**Item 7.****Development Application: 44-48 O'Dea Avenue, Waterloo**

File No.: D/2018/614

**Summary**

Figure 21: SLEP 2012 Height of Building Map

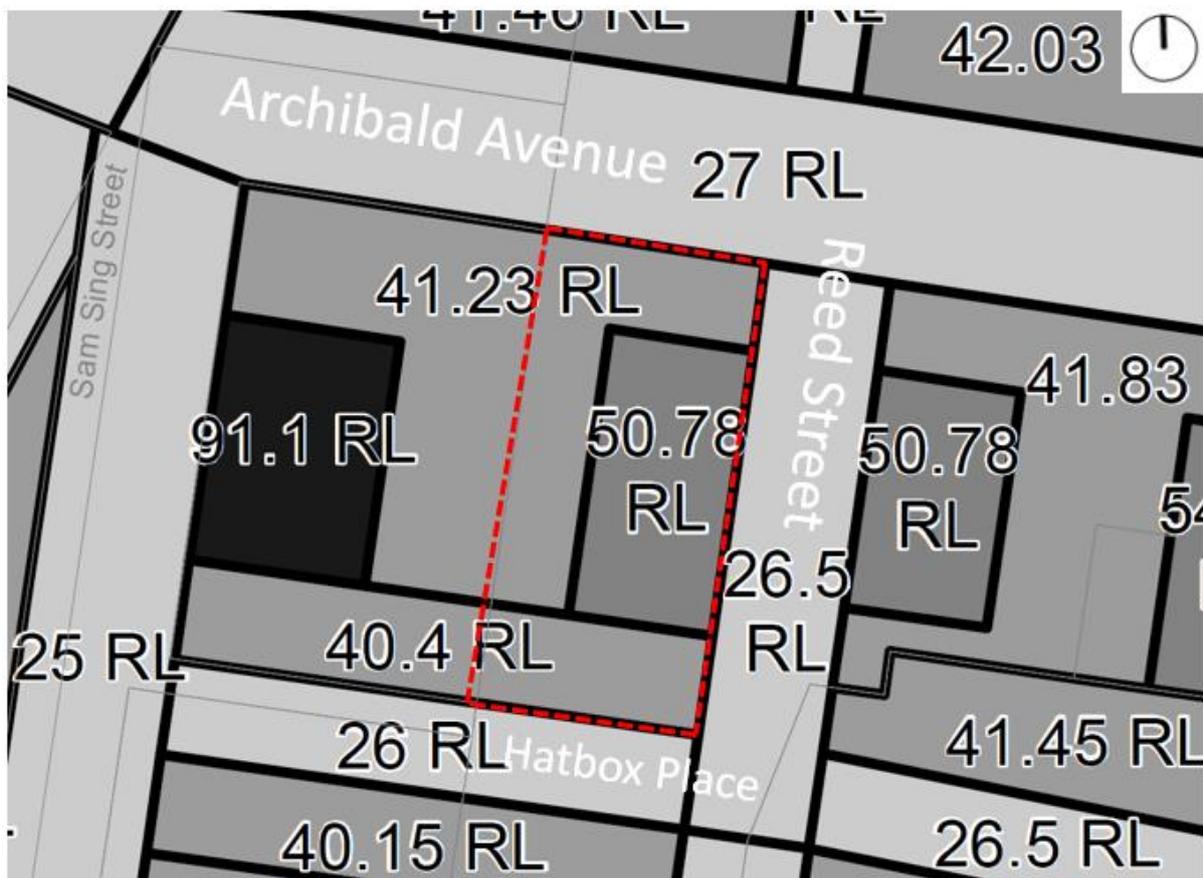
- 50.78 RL - applies to the centre of the site and to the Reed Street frontage;
- 40.4 RL - applies to the southern edge of the site fronting Hatbox Place; and
- 41.23 RL - applies to remaining areas of the site to the west and to the north fronting Archibald Avenue.

53. An extract of the SLEP 2012 height of building map is provided in Figure 21 below, with the subject site outlined in red:

**Figure 22:** Level 4 floor plan highlighting areas of non-compliance with SLEP height of building

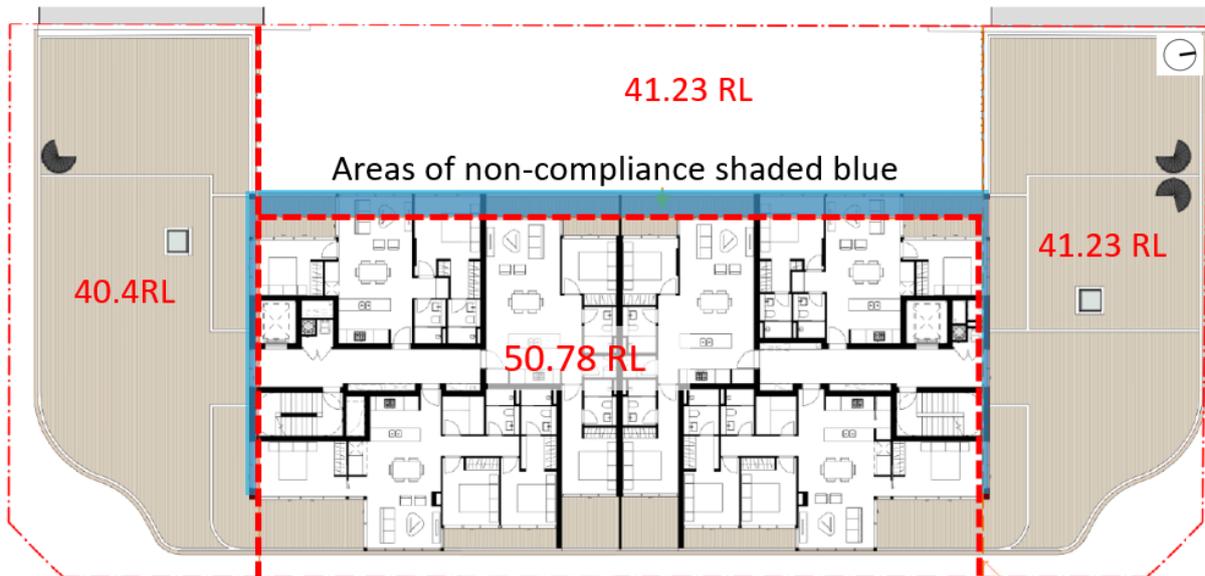
55. The floor plan of level 4 is shown in Figure 22 which highlights the areas of non-compliance:

56. To the south (towards Hatbox Place), the floor plate and architectural detailing of the central taller part of the building extends within 40.4 RL zone by approximately 0.73m in depth. This component of the building breaches the maximum 40.4RL height standard by 7.4m or 18.3%.
57. To the north (towards Archibald Avenue) and to the west, the floor plate and architectural detailing of the central taller part of the building extends within the 41.23 RL zone by approximately 0.55m and 1.5m in depth, respectively. This component of the building breaches the maximum 41.23 RL height standard by 6.57m or 15.9%.
58. Elevations of the proposed building with the SLEP 2012 height of building lines indicated are shown in Figures 23 - 26:

66. The applicant's written request has adequately demonstrated that there are sufficient environmental planning grounds to justify varying contravening the development standard.
67. Council officers agree with the justification provided in the written request which explains that the detailed design of building demonstrates that the components of the building which breach the height standard facilitate a more functional floor plate resulting in apartments which have a high level of amenity and compliance with the ADG.
68. The applicant's justification that the components of the building subject to the non-compliance do not result in adverse environmental planning impacts by way of urban design, view loss or overshadowing are supported.

**Figure 27:** SDCP 2012 height in storeys map

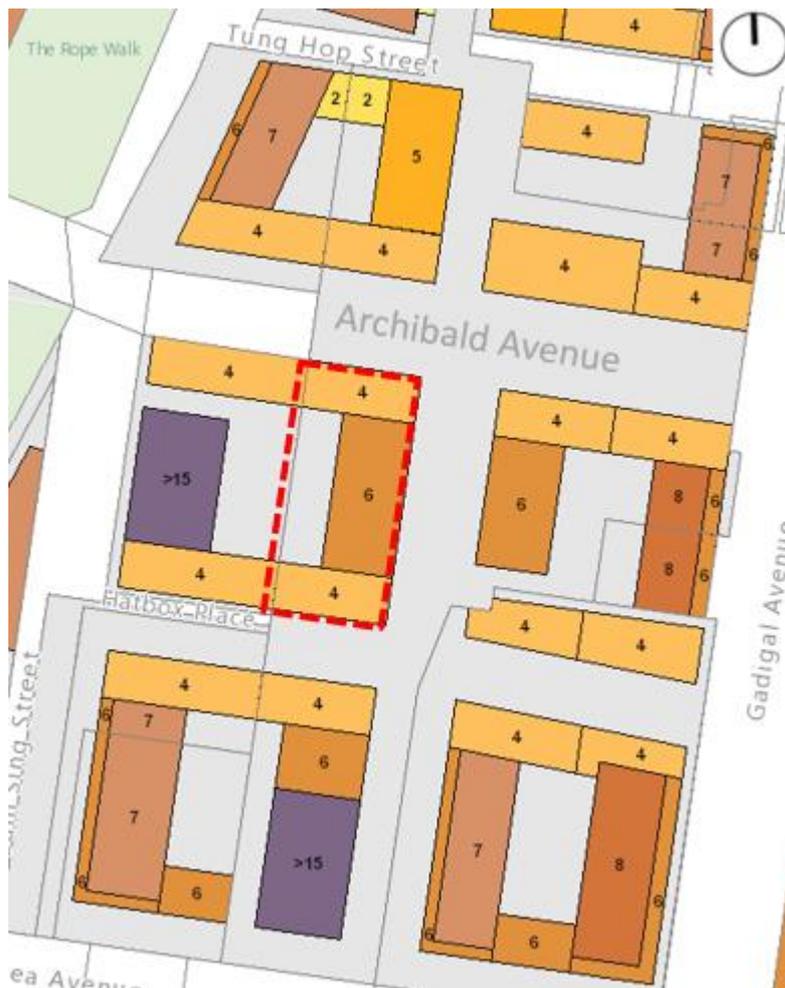
- (b) The proposed components of the building subject to the breach still provide for a development which has a taller building on part of the site with appropriate transition to the two 4 storey components. The component of the building subject to the height of building breach does not compromise a clear transition between the 6 storey and 4 storey components of the building. Under the SDCP 2012, the height in storeys provisions for the site and immediate surrounding area in the Lachlan Precinct generally require 4 storeys with a higher component of between 5 to 8 storeys as shown in Figure 27. The proposed development complies with the strategic intent of these provisions.

- (c) Given the above, the proposal is also considered to meet the objectives for Green Square in that the amenity of the public domain will be maintained as the taller part of the building is still restricted to one part of the site. In addition, the proposed development maintains the existing future and built form character of the immediate surrounding area through maintaining the 4 storey components of the building.

**Figure 28:** SDCP 2012 'Figure 5.88 Lachlan Precinct Access and Circulation' (the subject site is outlined in red)

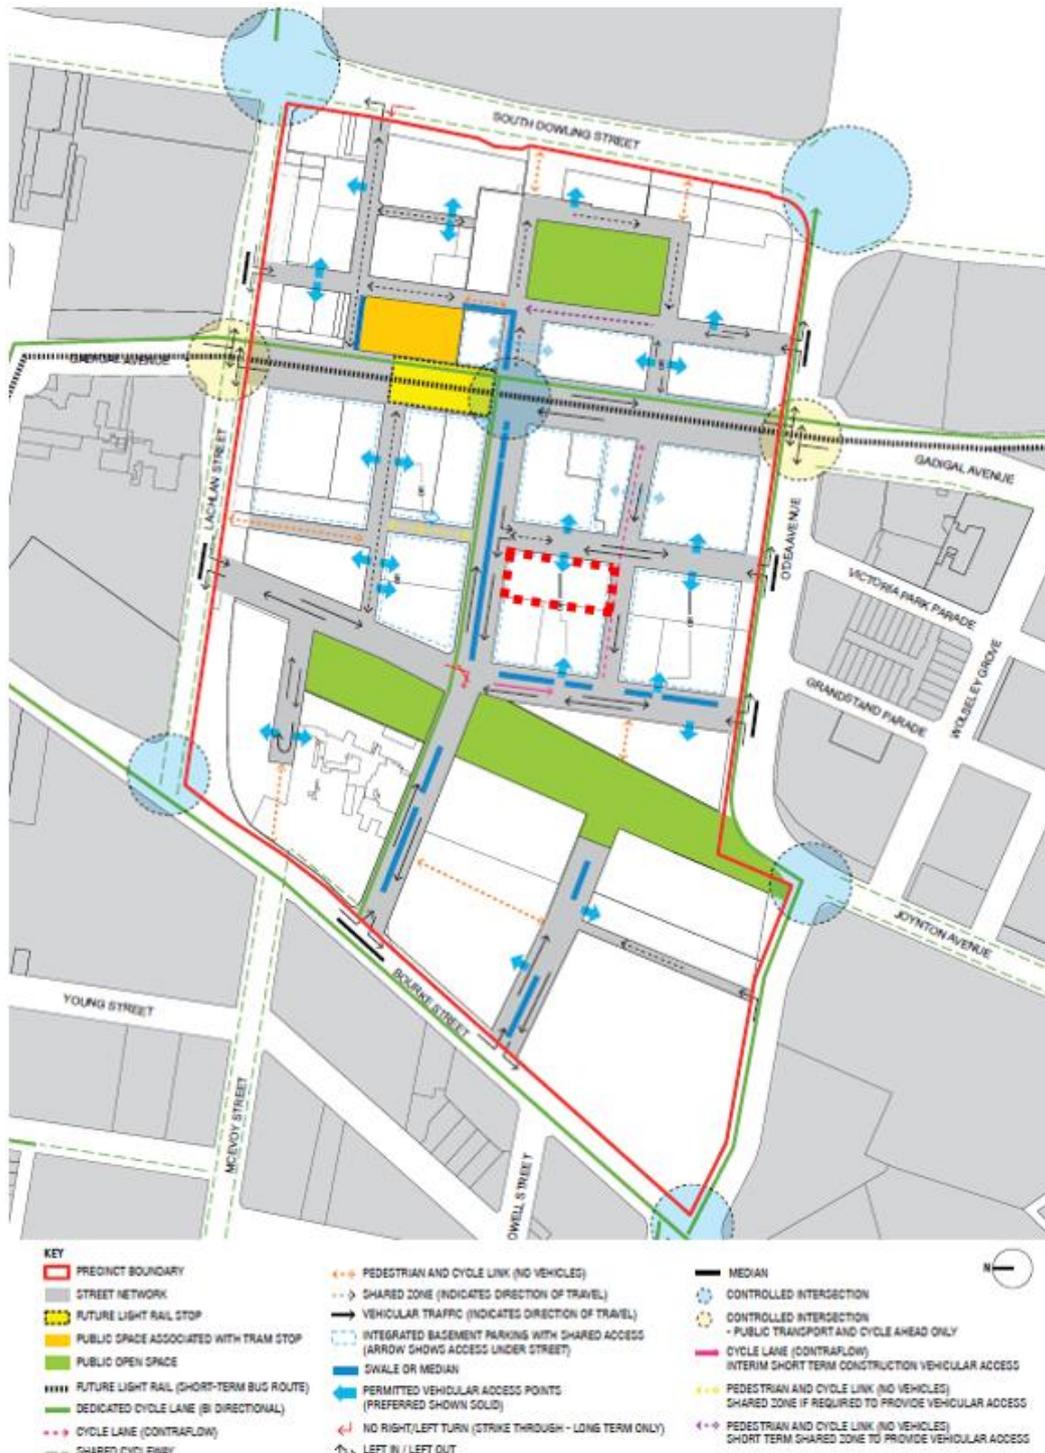
89. Section 5.4.3.9 (1) of SDCP 2012 stipulates that vehicle access points are not permitted along Gadigal Avenue or within the Archibald activity strip, and are to be situated instead on lower order streets in accordance with Figure 5.88: Lachlan Precinct - Access and Circulation. Figure 5.88 of SDCP 2012, below, shows two potential basement and vehicular access options for this site, being either:

- (a) a vehicular access point to the site from Reed Street (as is proposed in this application); or
- (b) a consolidated basement with the adjacent development to the west, now known as 5 Sam Sing Street, Waterloo, and the single vehicular entry point being either from Reed Street or Sam Sing Street.

94. While the driveway width was not reduced in the amended application, the extent of the blank facade components such as the fire hydrant were reduced in length. In addition, 'hit and miss' brickwork is now provided to the wall western courtyard wall which separates the communal open space from the ground floor loading area. The rationale is to potentially allow views of the landscaped open space as suggested by DAP. The proposed garage door was amended to provide 80% permeability and is dark grey to blend in with the proposed colours of the ground floor Reed Street facade. In the circumstances of the case, this proposed non-compliance is considered to have merit and is supported in this case.
